## Technical Guidance Committee Meeting

### Minutes

Thursday, July 18, 2013

Figure 3-1. [Dimensional-Horizontal separation distance](#) requirements for a standard drainfield (IDAPA 58.01.03.008.02.d and 58.01.03.008.04).

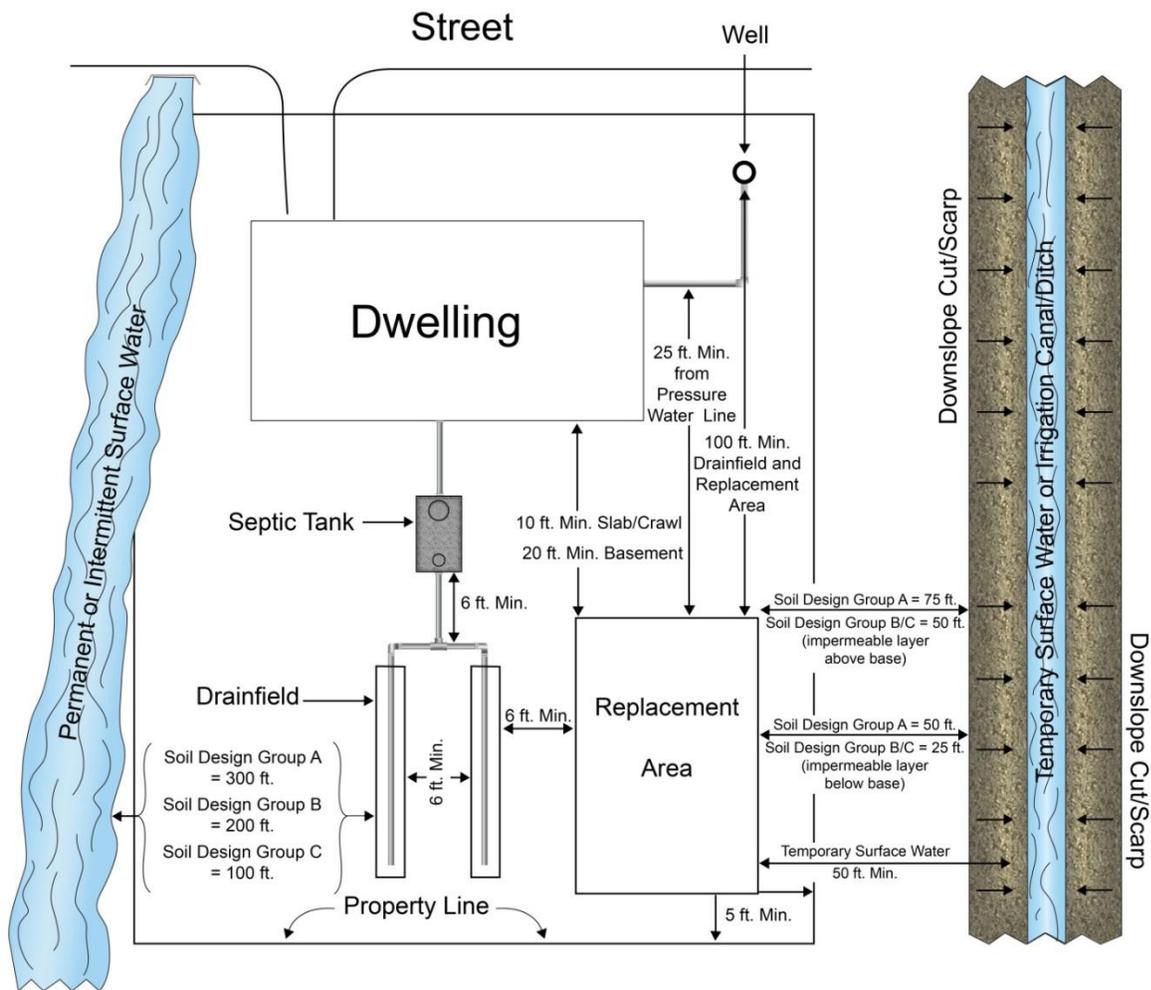
This section was posted for public comment. There were no public comments received on this section. Bob Erickson asked that figure 3-1 be amended to add the 5 foot setback to the property line from the drainfield. Joe Canning asked that the drainfield label and arrow be moved over in figure 3-2. Tyler Fortunati stated that both changes would be made on the final document.

**[Figure 2-4. Temporary ground water monitoring well design.](#)**

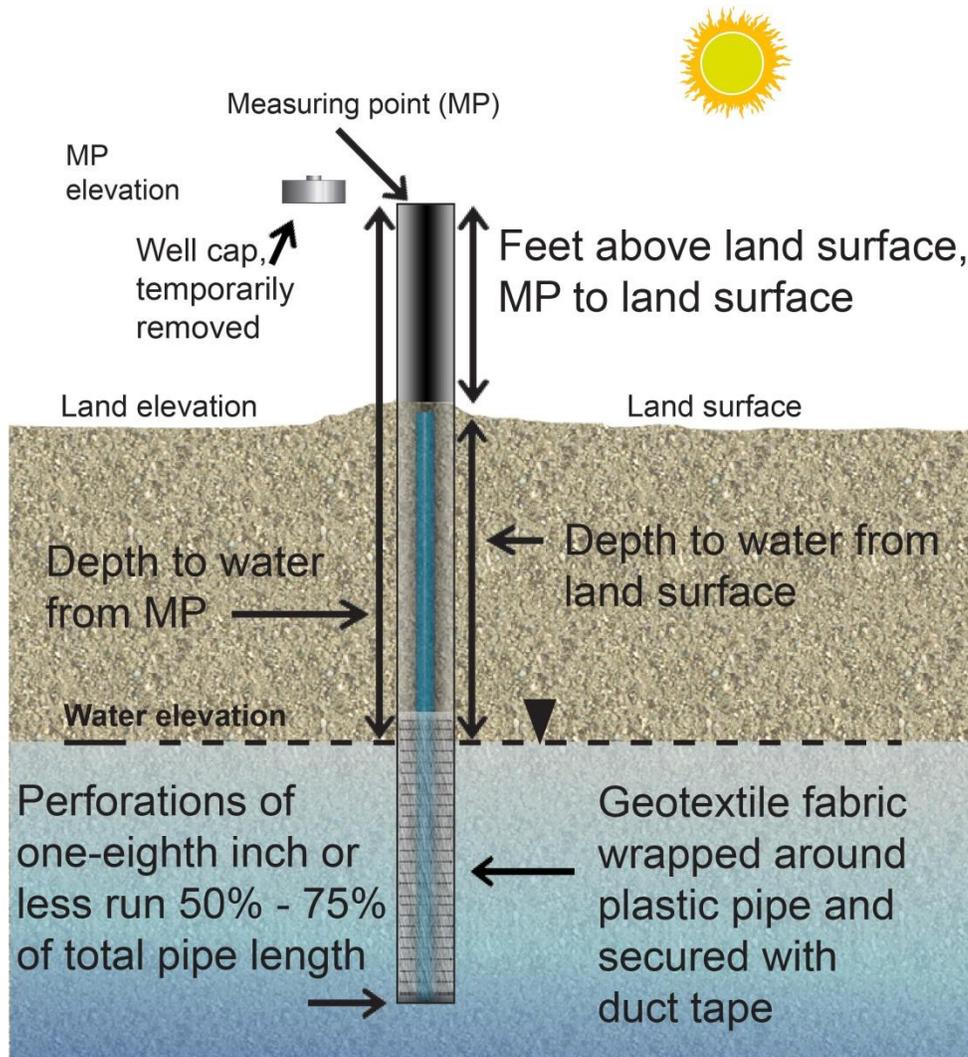
Joe Canning discussed Figure 2-4 Temporary ground water monitoring well design, and recommended adding emphasis of mounded soil sloping away from the top of the well. This should be done to help reduce the chance of surface runoff accumulating around the temporary monitoring well and moving down the side of the casing which gives a false reading of ground water levels. Tyler Fortunati stated that he would have this amendment added to the figure.
